P & ID
CONTROL ROD DRIVE
HYDRAULIC (RD)
M. H. ZIMMER NUCLEAR POWER STATION UNIT 1
THE CINCINNATI GAS & ELECTRIC CO.
COLUMBUS & SOUTHWEST OHIO ELECTRIC CO.
THE DAYTON POWER & LIGHT CO.

DRAWING NO. M-56
SHEET 1 OF 3

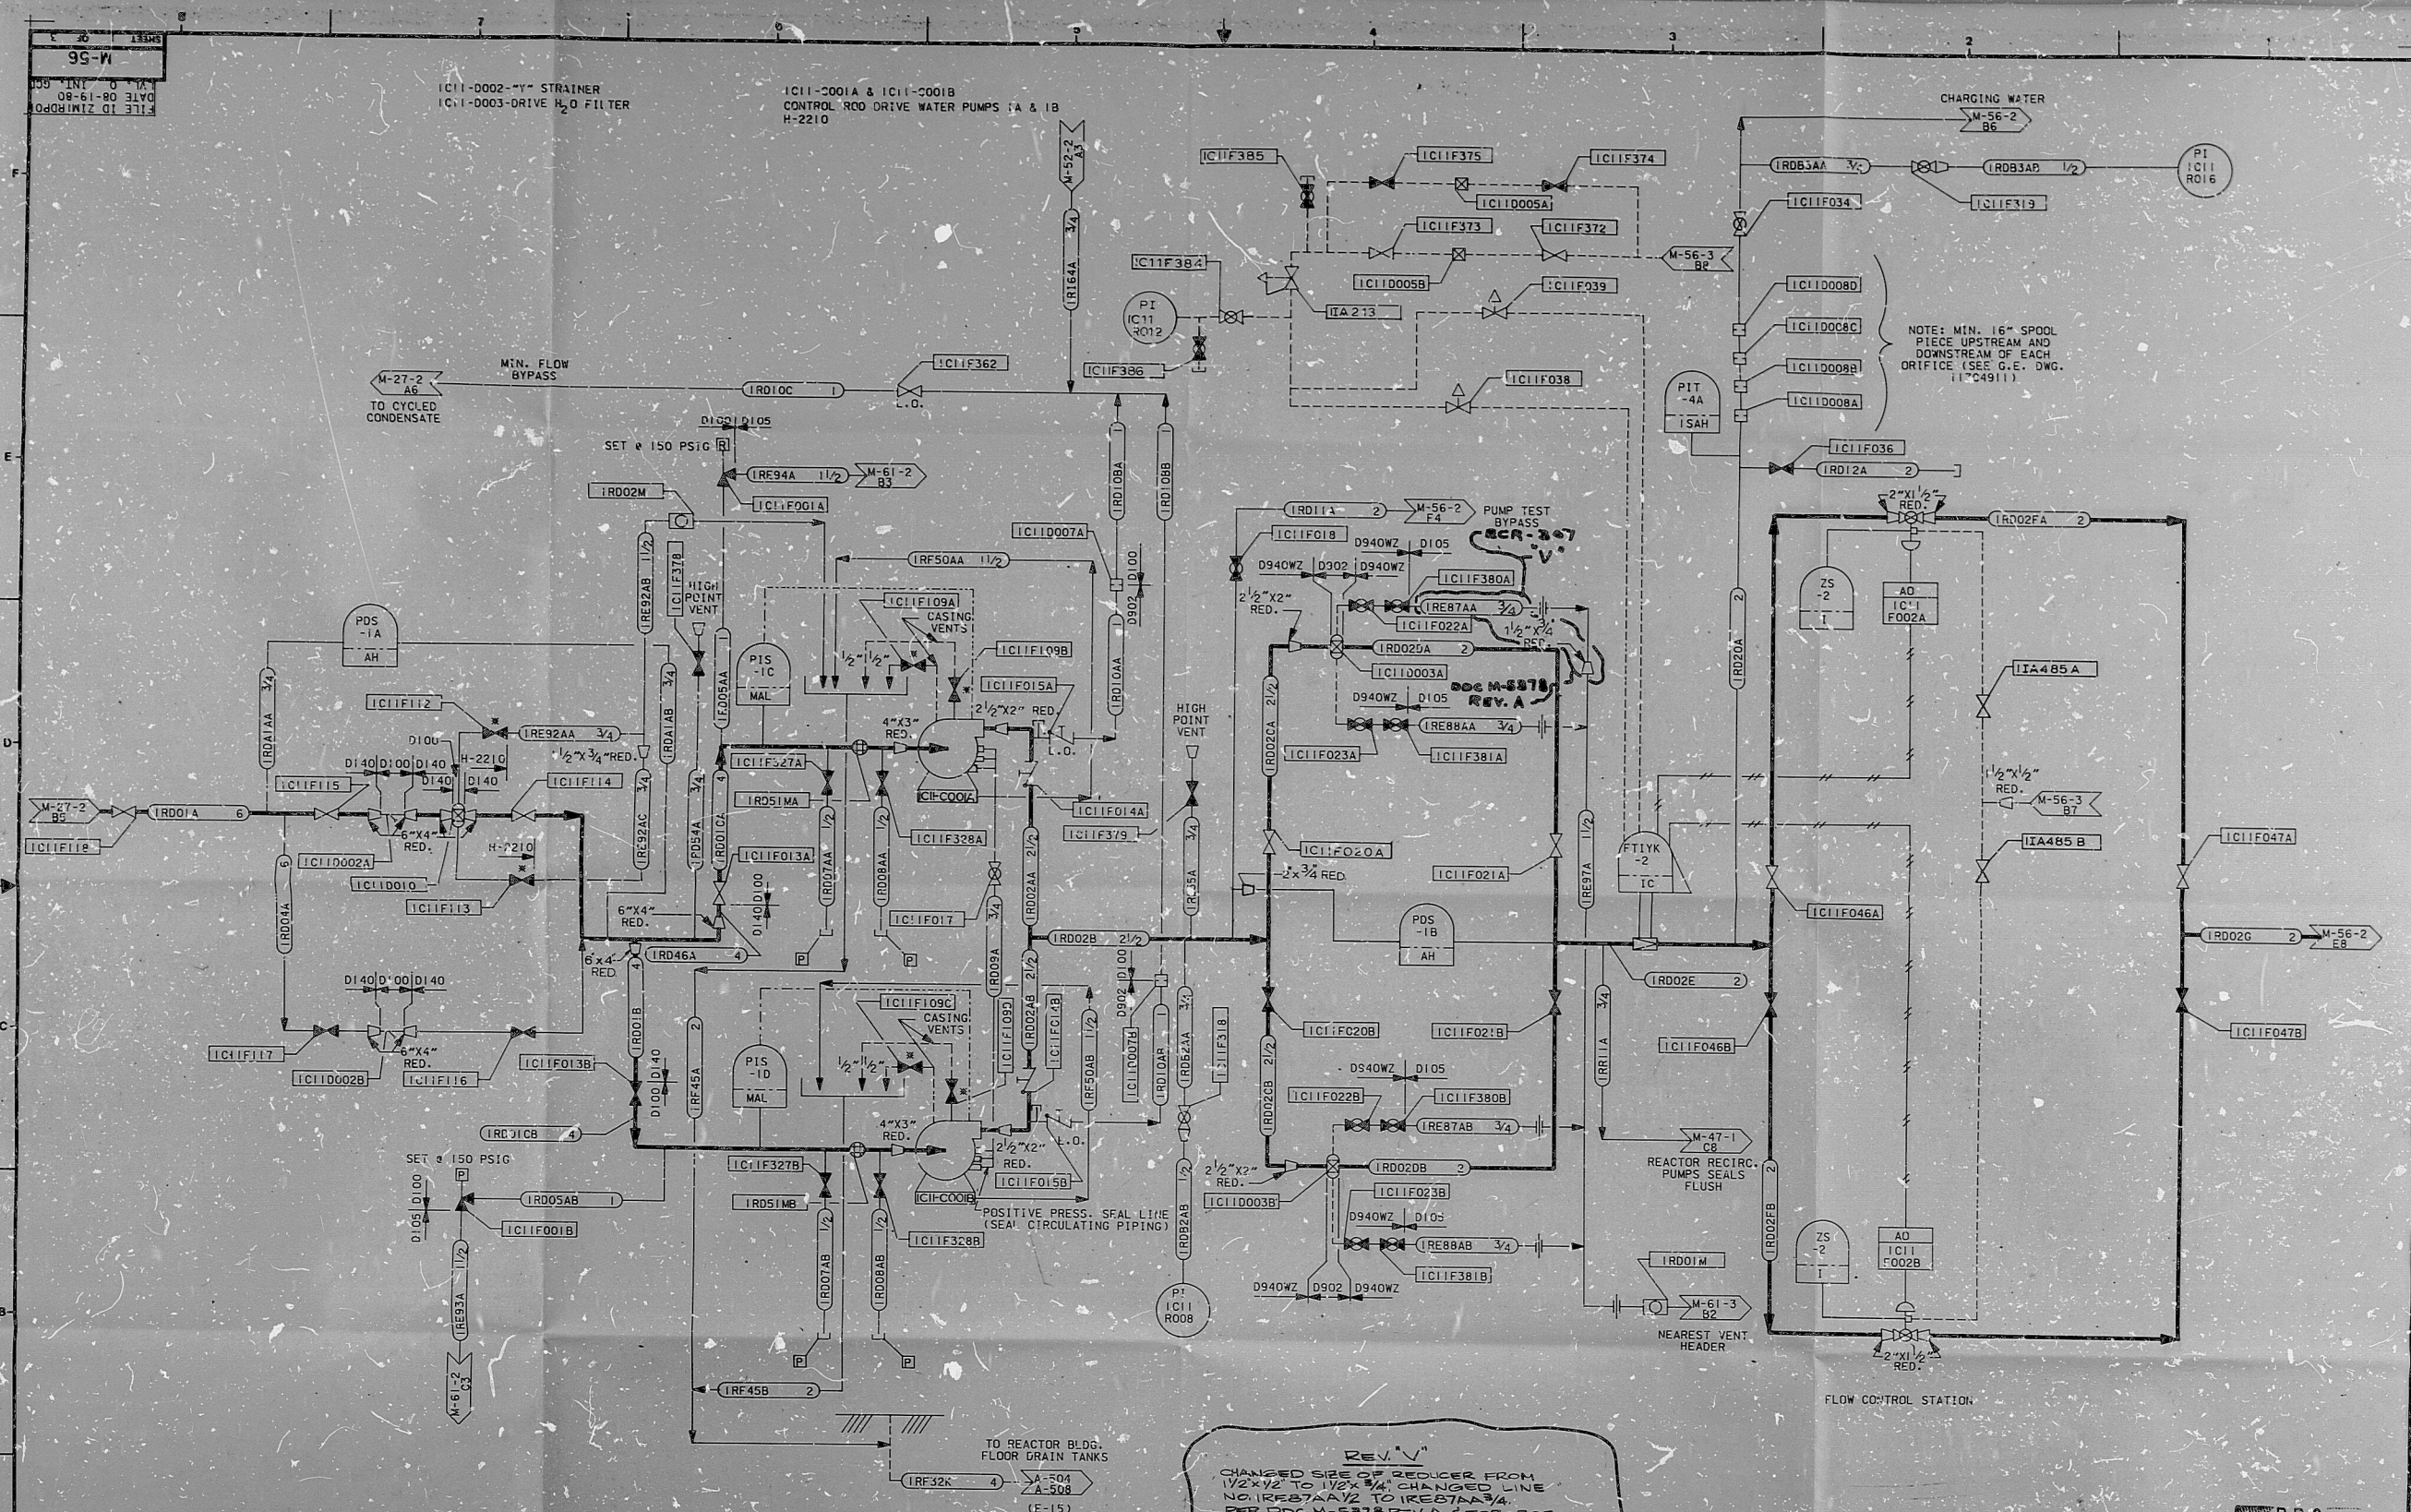
REV. V
CHANGED SIZE OF REDUCER FROM 1/2"x1/2" TO 1/4"x1/4" CHANGED LINE NO. IRE87AA1/2 TO IRE87AA3/4 PER DOC M-5373 REV. A & ECR-307 FOR FILE RECORD RELEASE PER MT-2000
